U S NAVY RESPONSE TO SOUTH CAROLINA DEPARTMENT OF HEALTH AND
ENVIRONMENTAL CONTROL COMMENTS TO RCRA FACILITY INVESTIGATION REPORT
ADDENDUM AND CORRECTIVE MEASURES STUDY WORKPLAN-AREA OF CONCERN 597
(AOC 597) ZONE E WITH TRANSMITTAL CNC CHARLESTON SC

AOC 597 Zone E

RTC RFI Report Addendum + CR3 Workplan (RO)

Re: CH2M-Jones' Responses to Comments by SCDHEC regarding the *RFI Report Addendum & CMS Work Plan, Area of Concern 597, Zone E, Charleston Naval Complex* (Revision 0)

FIGURE 10.46.2
WIPE SAMPLE LOCATIONS
AOC #597
SUBSTATION
BUILDING 91

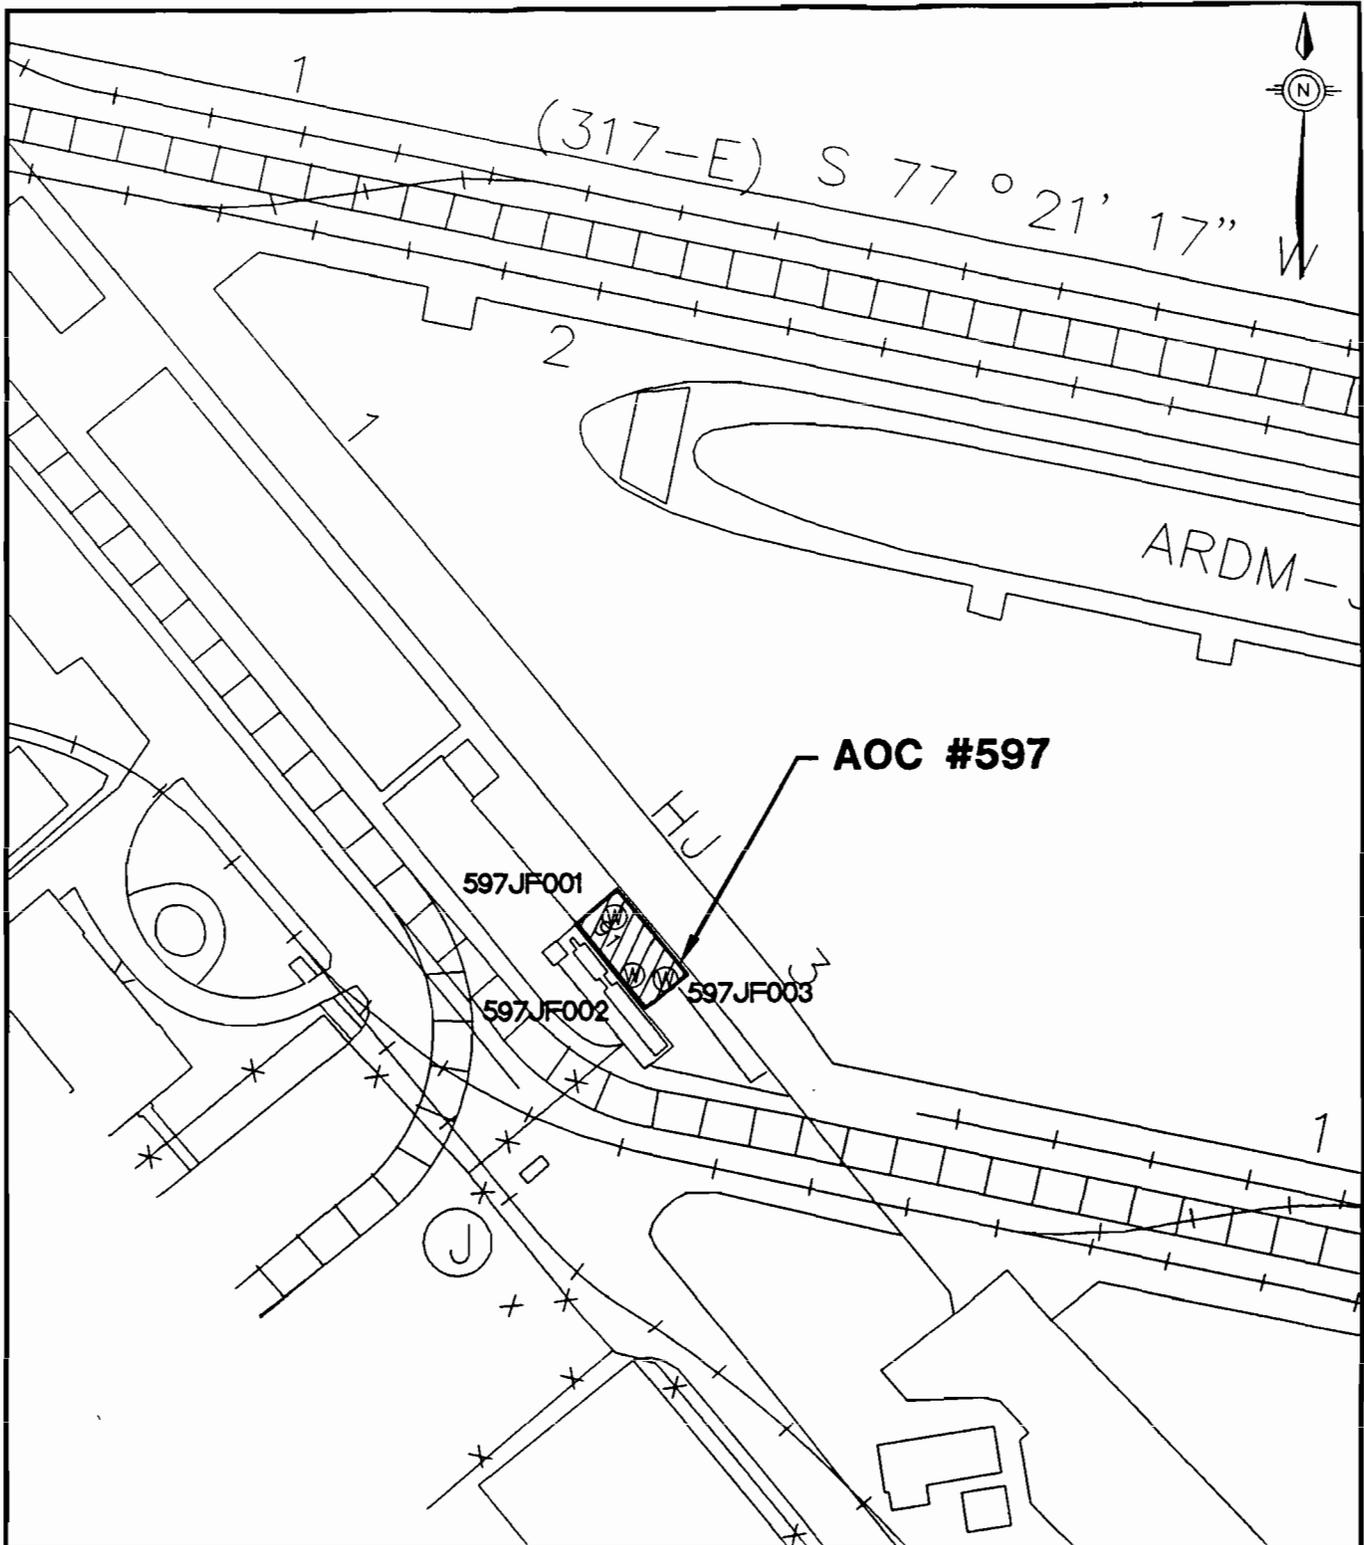
This section presents the results of the wipe sampling conducted in the electrical substation. Sample locations were biased toward areas of the highest possible contamination. Two of the three samples had a detectable quantity of PCBs at 2.7 $\mu\text{g}/\text{cm}^2$ and 2.8 $\mu\text{g}/\text{cm}^2$. However, the locations of these detects is not presented in the documents. Please indicate where these detections occurred.

Furthermore, there is no rationale as to why these detections are not of concern. The Department recommends using 40 CFR 761.125(c)(4)(ii) under the Toxic Substance Control Act (TSCA) as a reasonable screening tool to determine if additional action is required to remove residual PCB contamination from solid surfaces. This section of TSCA states that, for non-restricted access areas, high-contact outdoor solid surfaces shall be cleaned to 10 $\mu\text{g}/\text{cm}^2$. Considering the wipe samples have met this criterion, the surface of the storage area does not require any additional cleaning. Please provide this rationale or other rationale deemed appropriate by the Navy to demonstrate that the wipe sample results are not of concern. Please note that this comment applies to any future sites for which PCB wipe sampling was conducted.

Figure 10.46.2 from the Zone E RFI Report, Revision 0 (see attached copy) shows the wipe sampling locations. The figure indicates that these samples were collected within Building 91. The Revision 0 RFI report also indicates that concrete surfaces were wiped. Wipe locations were determined in the field based on an attempt to bias the sample results to worst-case situations, based on the location of PCB-containing equipment and any visual evidence of spills or leaks.

With regard to the question as to why no rationale was provided to explain why the PCB detections were not of concern, the answer is that there are no RCRA Corrective Action risk-based criteria to use as comparison for these values. Note that the TSCA-referenced cleanup value (10 $\mu\text{g}/\text{cm}^2$) is not a risk-based concentration.

The Navy and CH2M-Jones does not have a significant concern about using the TSCA remediation criteria as a screening step at this particular site for evaluating wipe samples. We agree to revise the section of the report that discusses the wipe sampling results and use the TSCA criteria as a justification for no further evaluation of this issue at AOC 597.

However, we do have a concern about the 10 $\mu\text{g}/\text{cm}^2$ screening criterion being applied as a screening step or de-facto cleanup/investigation standard for this or similar sites at the CNC. The wipe criteria referenced in 40 CFR 761.125 apply only to spills of PCBs at concentrations of 50 ppm or greater, which are subject to the requirements of 40 CFR 761. Therefore, at sites at which there is no evidence that a spill of this nature occurred, there is no basis to apply or make mandatory the TSCA requirements of 40 CFR 761 as cleanup or investigation criteria.

In addition, the 10 $\mu\text{g}/\text{cm}^2$ criterion applies to non-restricted access areas, high-contact outdoor solid surfaces locations. There is no indication that the transformers at AOC 597

meet the criteria for designation as a non-restricted access areas, high-contact outdoor solid surfaces location. Given the location of AOC 597 in the industrialized portion of the CNC, the term "non-restricted access area" does not appear to apply, as this area is not accessible to the general public. Given the location of these wipe samples within Building 91, they do not appear to be in non-restricted access areas. Since the wiped surfaces were inside a building, the sample locations do not meet the criteria for "outdoor solid surfaces."

The term "high-contact surface" in an industrial setting refers to a surface which is repeatedly touched, often for relatively long periods of time. Manned machinery and control panels are examples of high-contact industrial surfaces. Examples of low-contact industrial surfaces include ceilings, walls, floors, roofs, roadways and sidewalks in the industrial area, utility poles, unmanned machinery, concrete pads beneath electrical equipment, curbing, exterior structural building components, indoor vaults, and pipes. Therefore, the concrete that was wiped would be considered a low-contact surface. A more appropriate criterion for AOC 597 or similar sites would be the allowable cleanup level for low-contact, outdoor surfaces in restricted areas of 100 $\mu\text{g}/\text{cm}^2$.

Because all of the detected concentrations are below both the 10 $\mu\text{g}/\text{cm}^2$ and the 100 $\mu\text{g}/\text{cm}^2$ criteria, CH2M-Jones believes that the detected PCBs in the wipe samples are not significant. Appropriate revisions to the Revision 0 RFI Report Addendum/CMS Work Plan will be made and provided to SCDHEC.
